TSTF-12-14
PROJ0753

SUBJECT: Response to NRC Request for Supplemental Information and Withdrawal Regarding TSTF-534, Revision 0, "Clarify Application of Pressure Boundary Leakage Definition"

**Response to NRC Request for Supplemental Information Regarding TSTF-534, Revision 0,
"Clarify Application of Pressure Boundary Leakage Definition"**

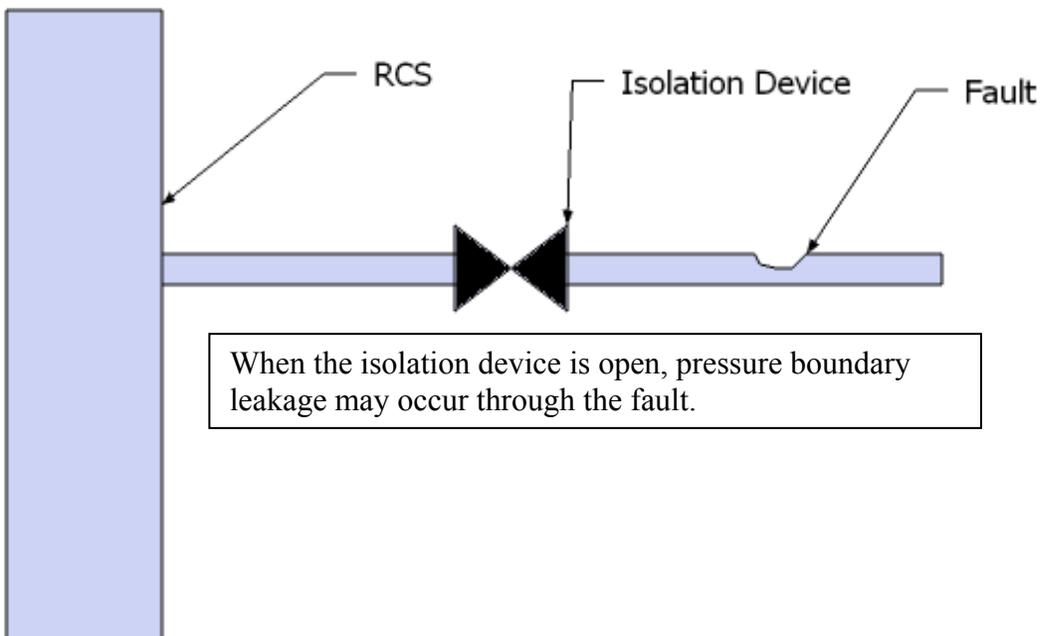
It is important to note the distinction between pressure boundary leakage (i.e., leakage through a fault in a RCS component body, pipe wall, or vessel wall) and the proposed limit on isolation device bypass leakage. The following diagram illustrates this distinction.
